Further Information for DEVB and PD

TLK 858 Further information

TKL 858 : Response to TD comment

Man Shing Hong (Hopewell) Company Limited	Swept Path Plan	Annex 1
	Scale 1:1000 0 10 20 30 40 50 m	October 2026

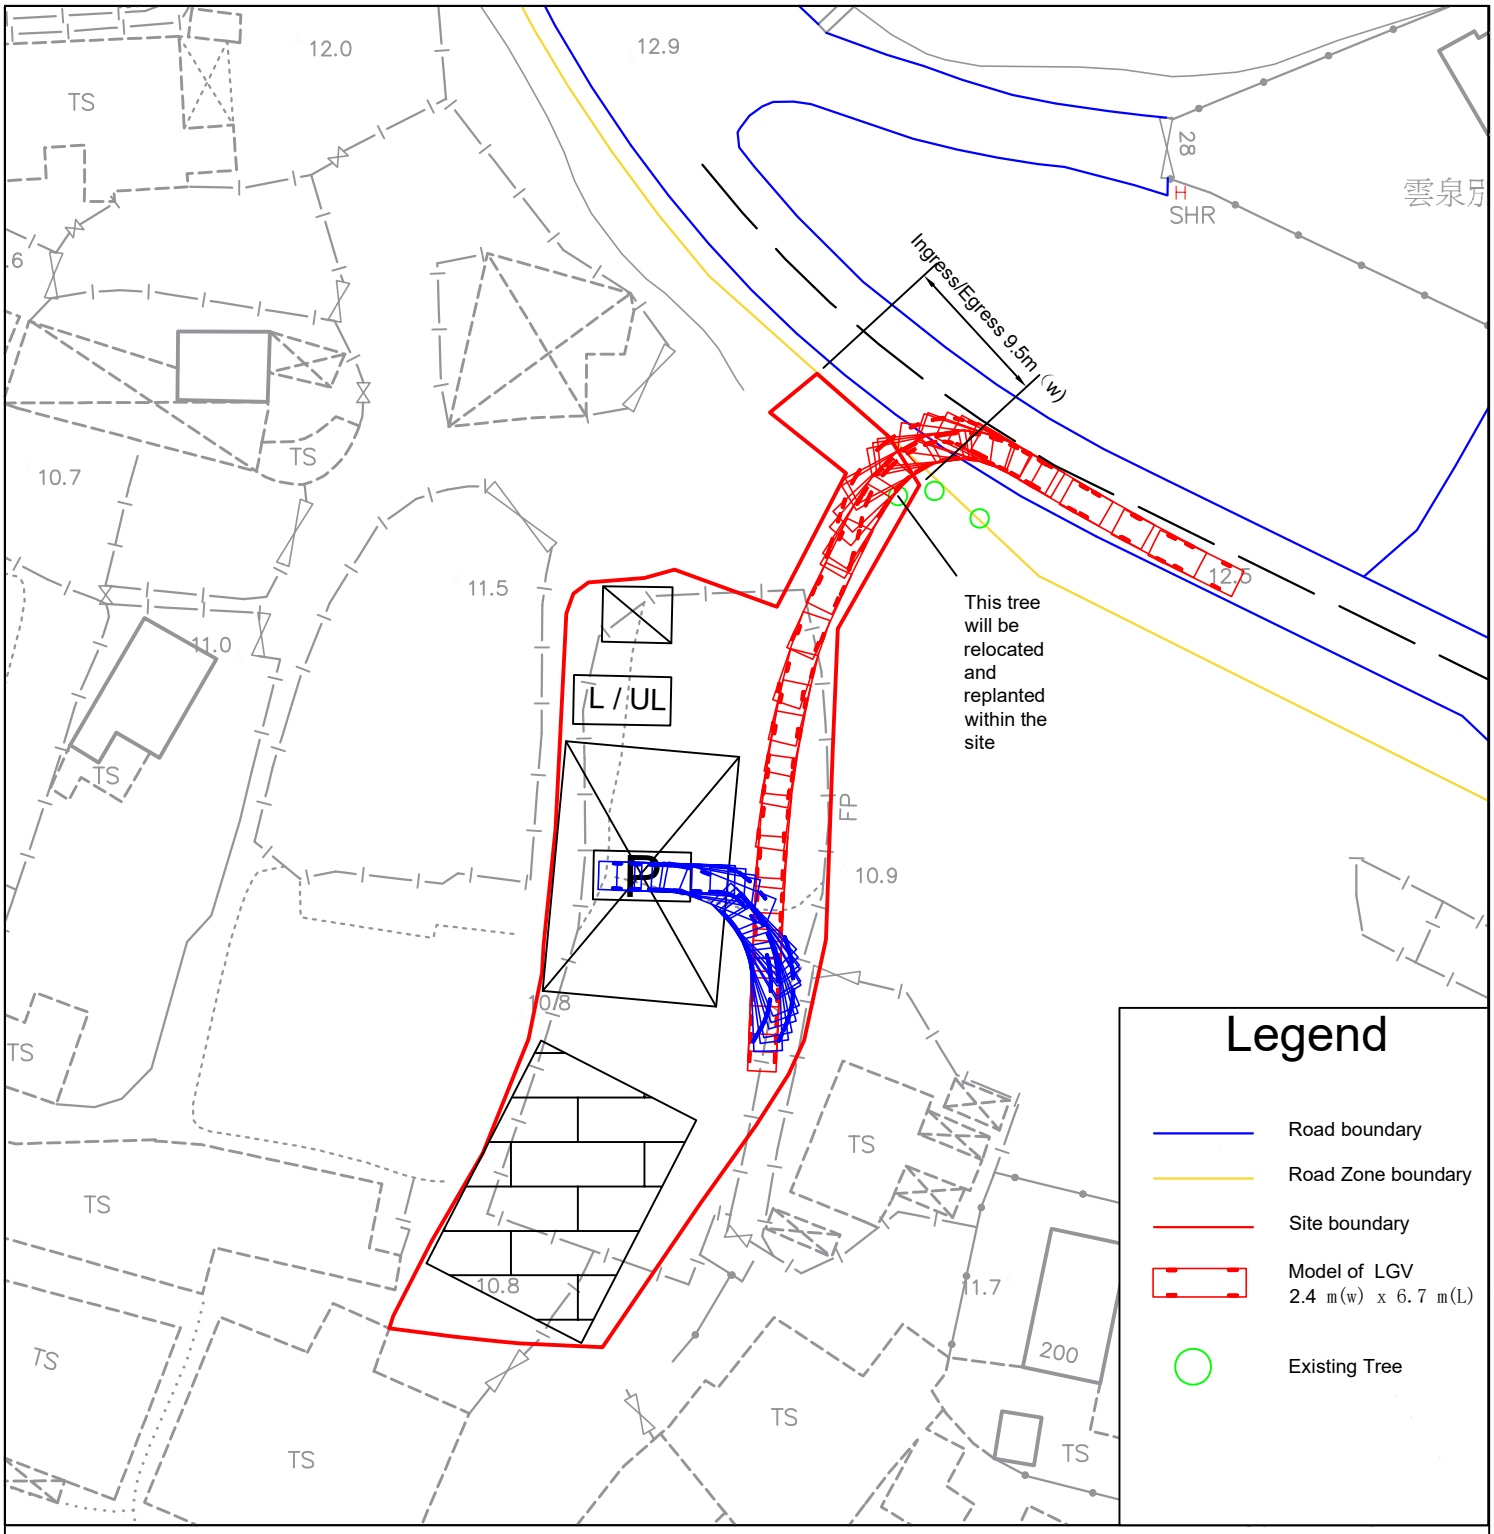
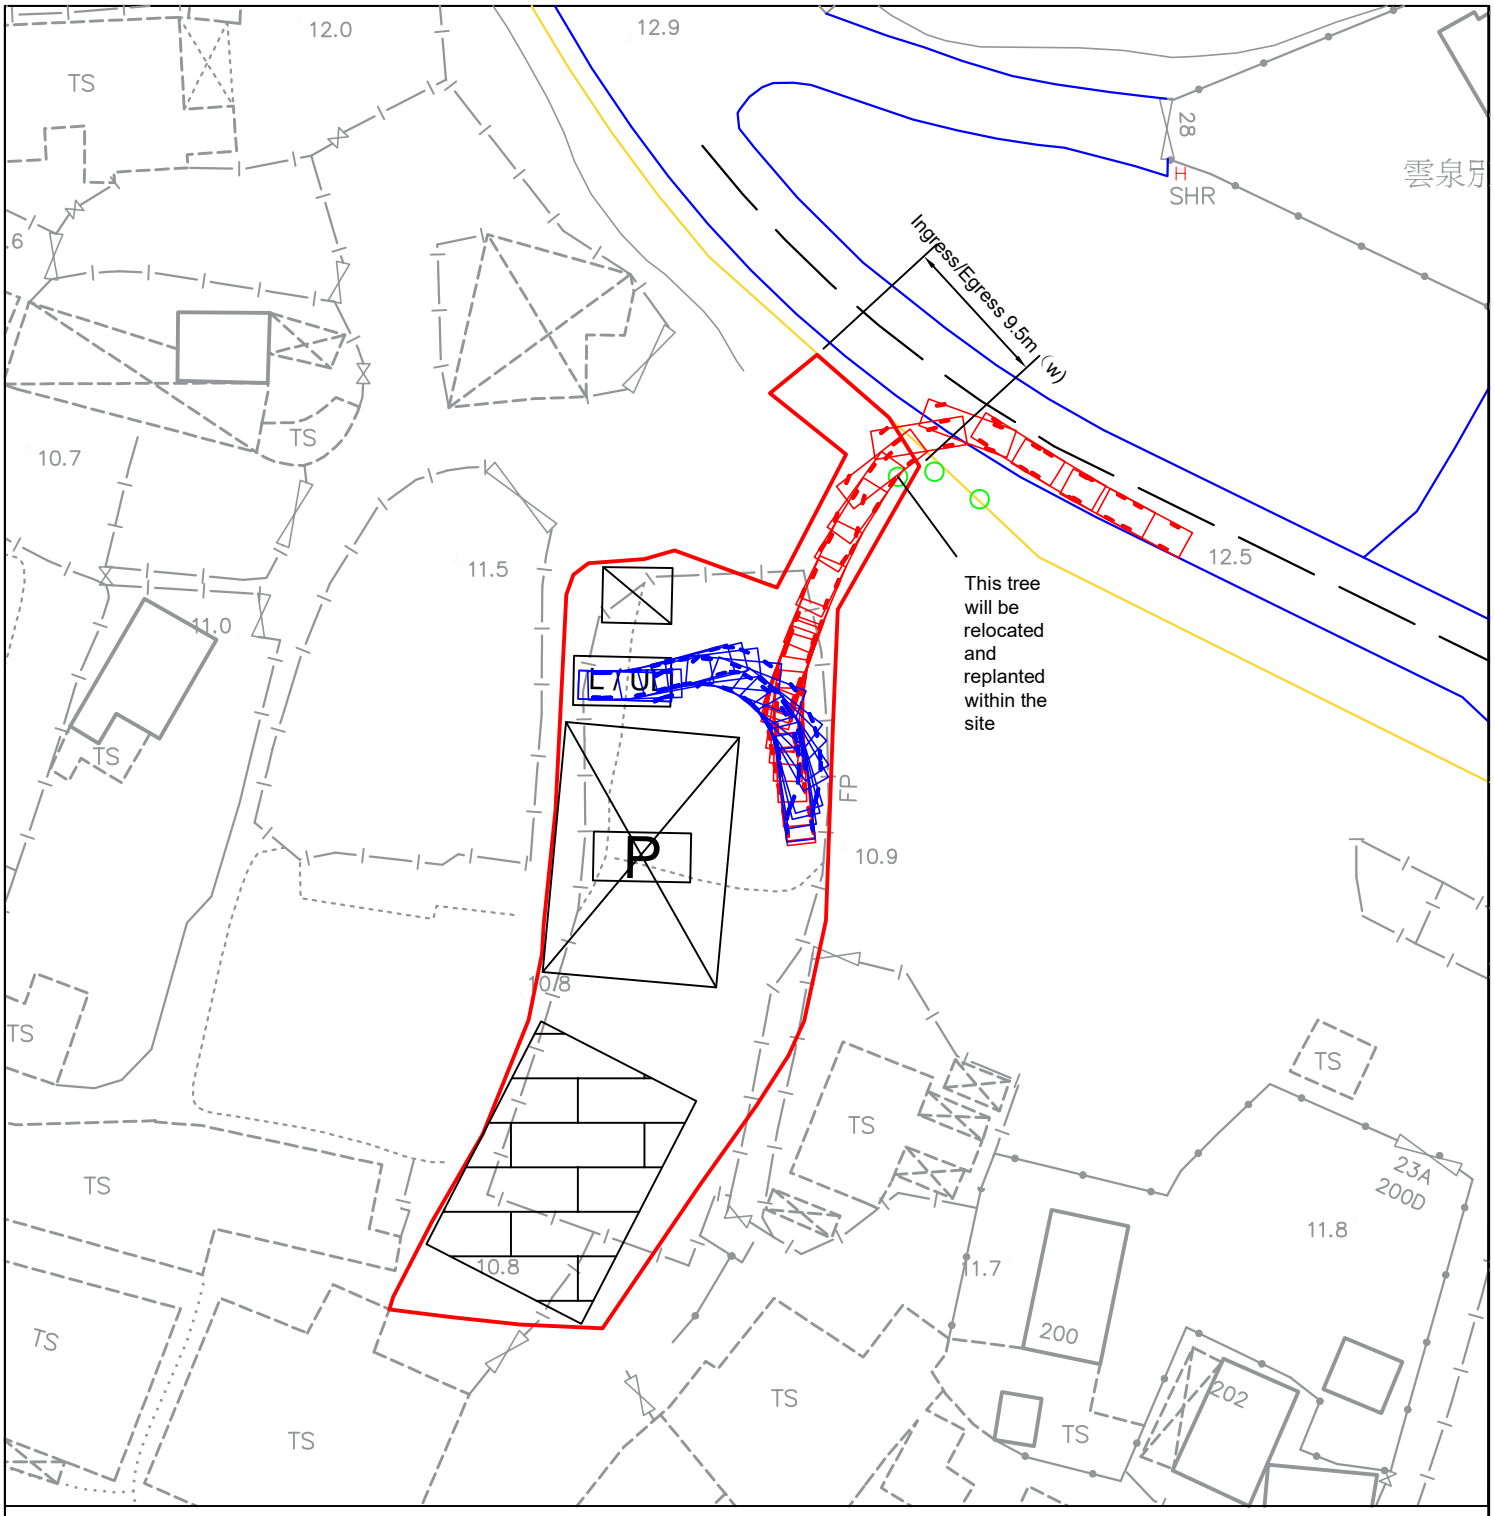
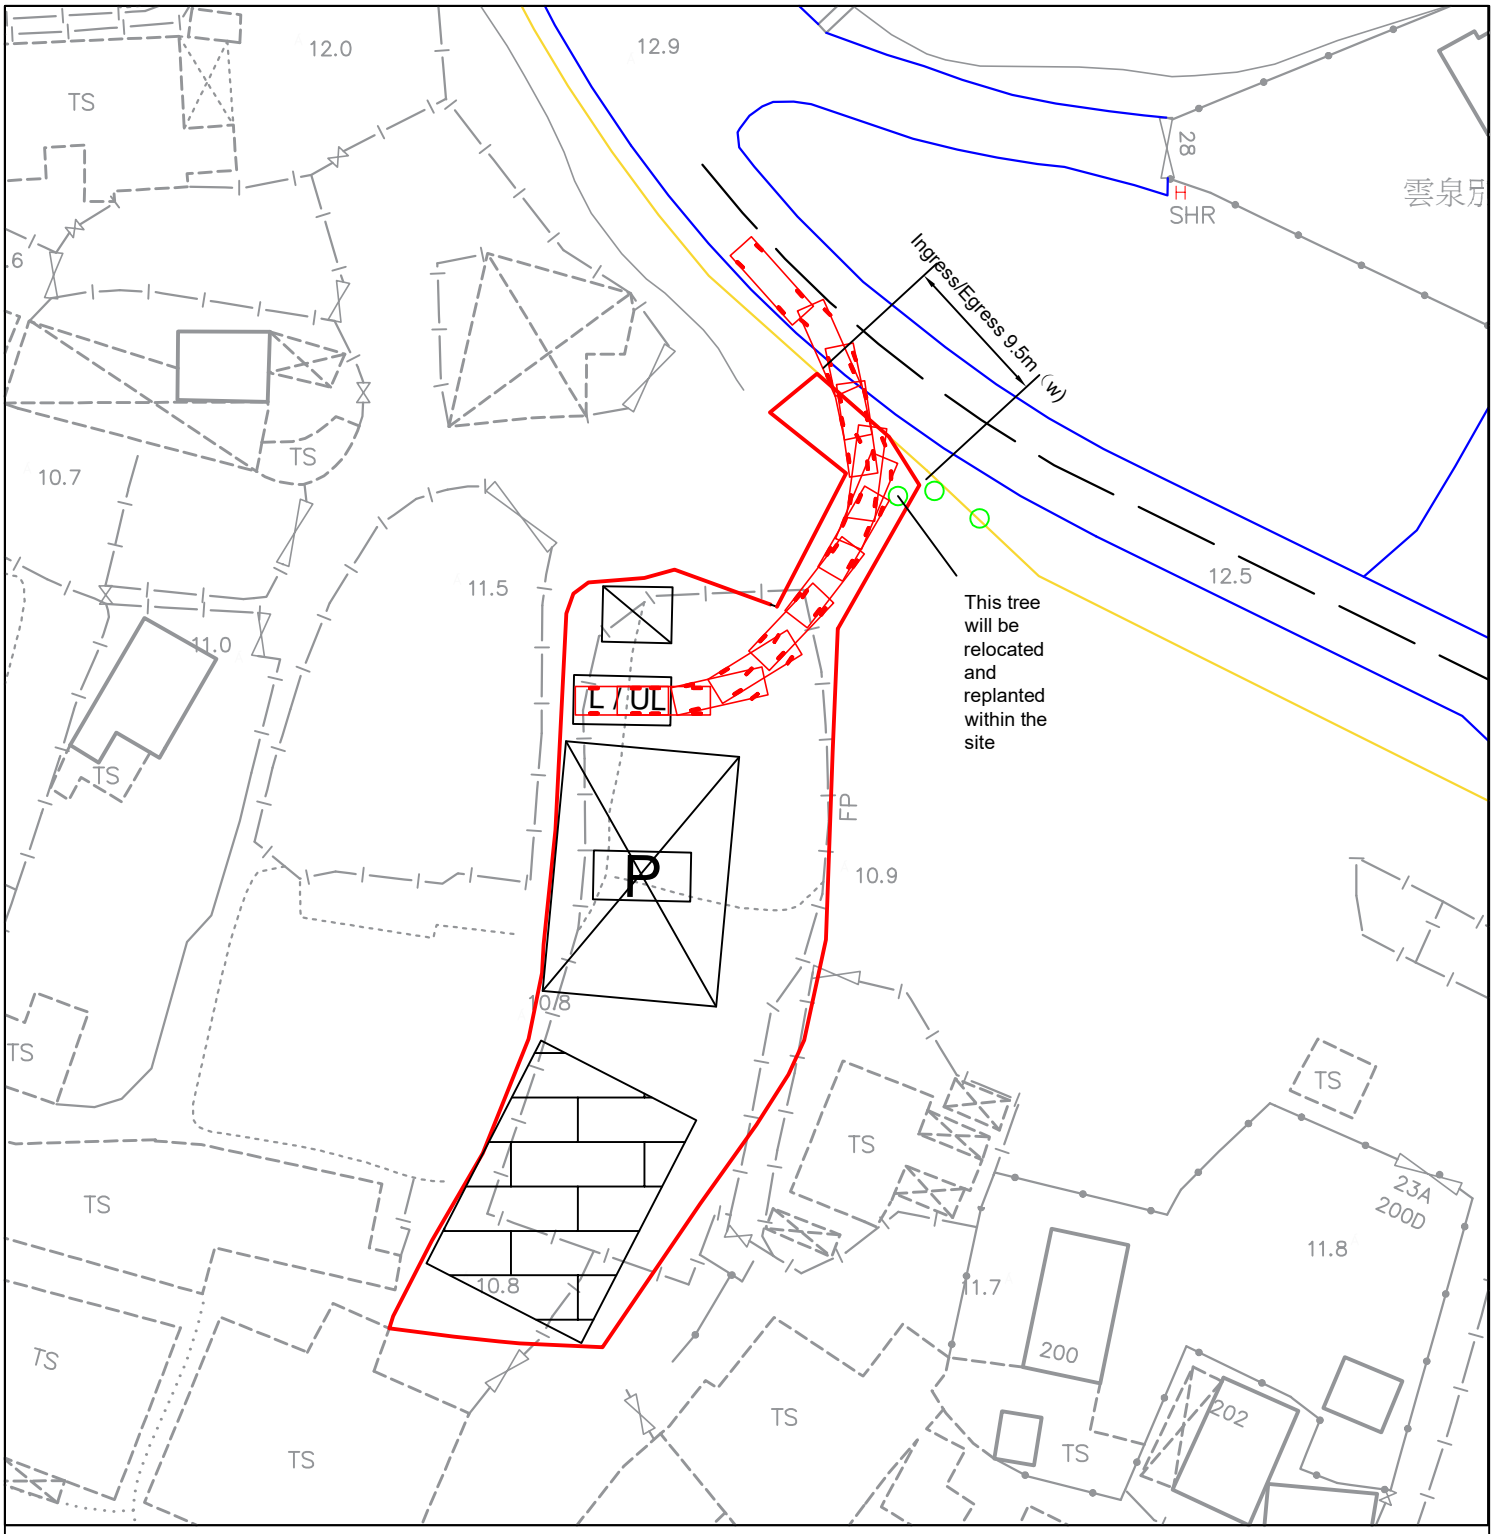
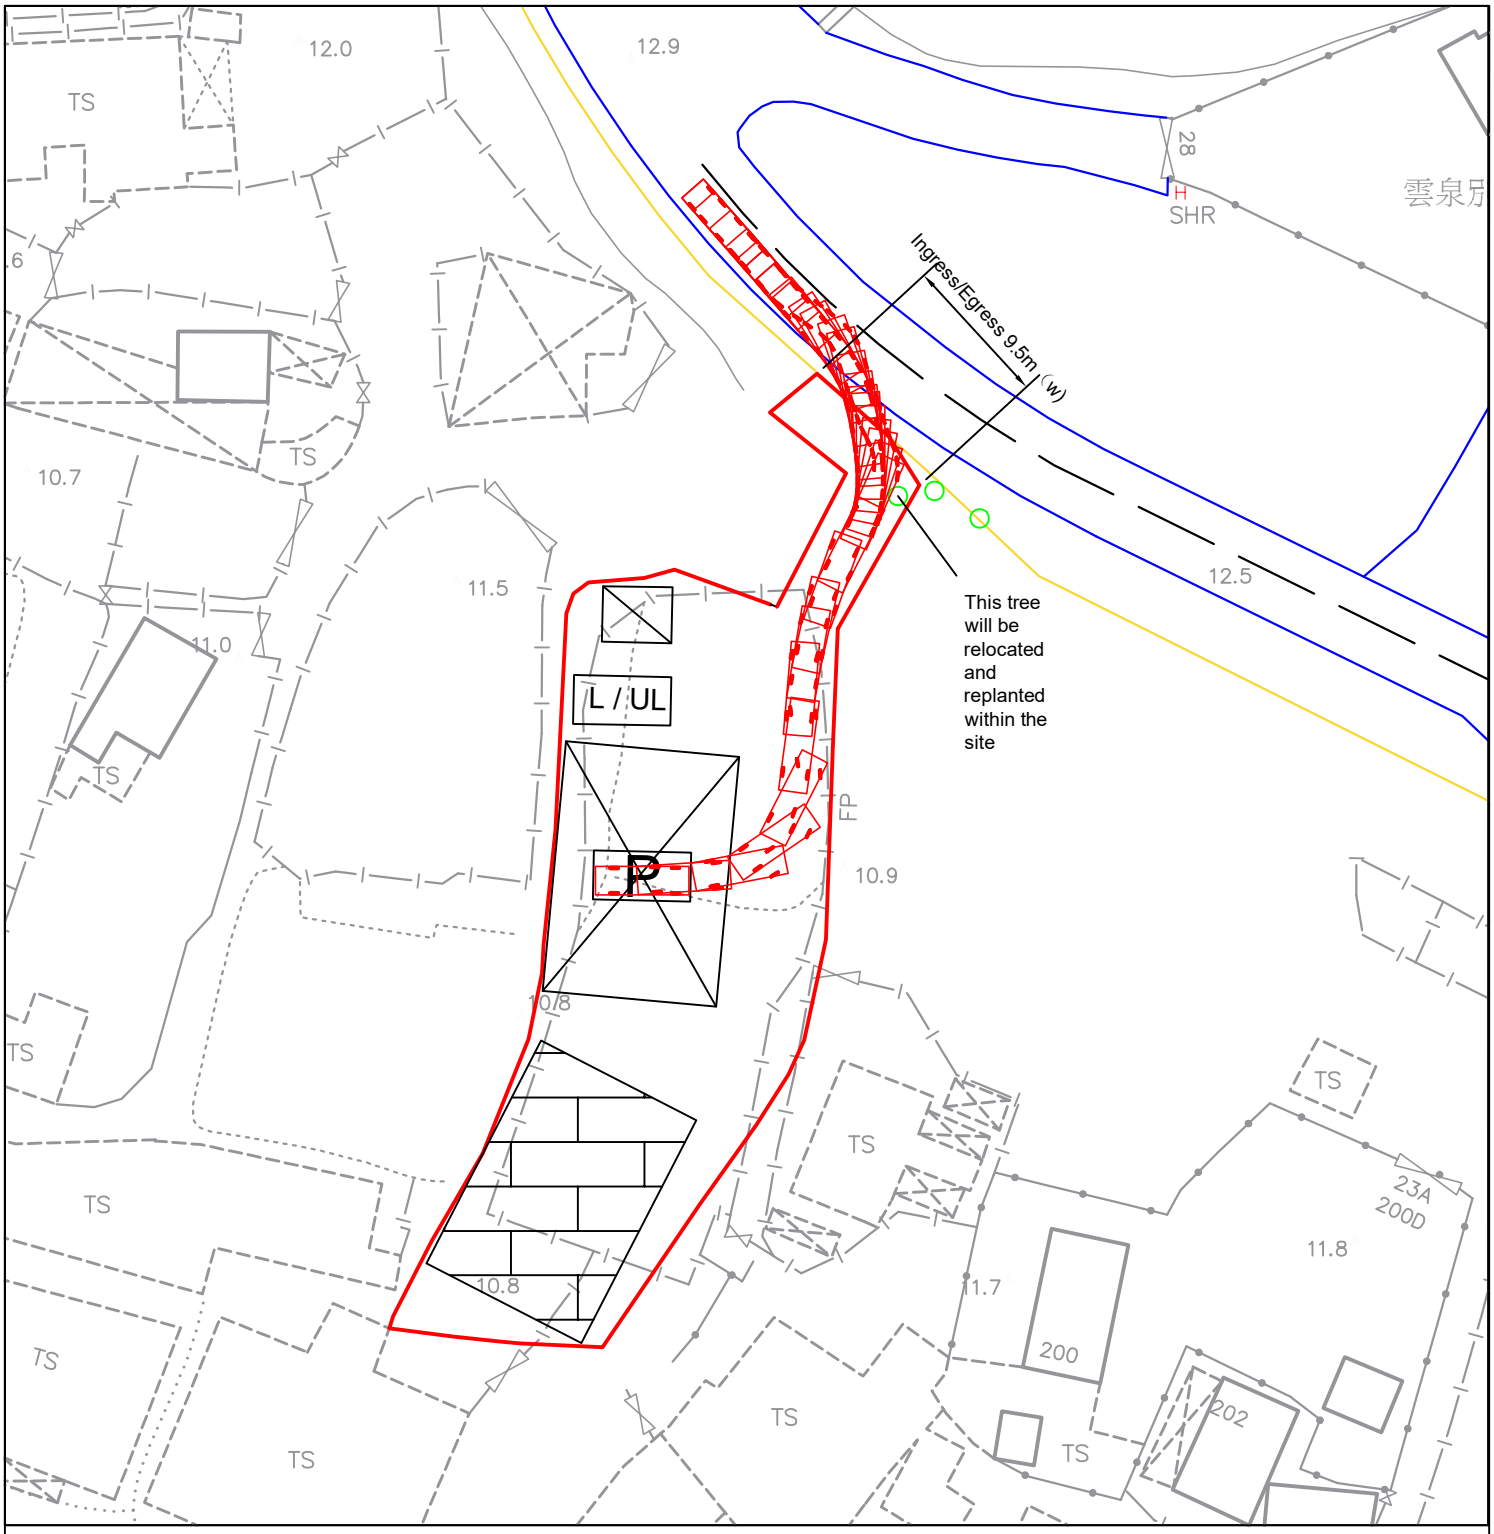
Comment 3
(iii) The applicant shall demonstrate the satisfactory maneuvering of the vehicles entering and exiting the application site, maneuvering within the application site and into/out of the parking and loading/unloading spaces, preferably using the swept path analysis;
Response to Comment
Please refer to Swept path plan
